SERVICE INFORMATION

Ref. No. 9708
Date Aug. 5, '97

MODEL	TX-SV444
ITEM	Changes of circuit

Service Procedures

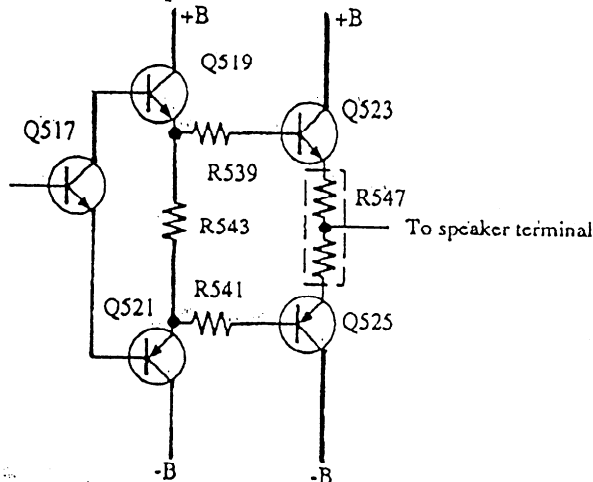
Symptom: No sound

Cause: The abnormal idling current flows according to the error tolerance of parts or the attachment position of thermal compensation transistors, and the power transistors, resistors etc. are broken.

Countermeasure: The parts below were changed to decrease the idling current.

1. Check all parts as shown below.

Spare parts kit : Part No. 0T1011
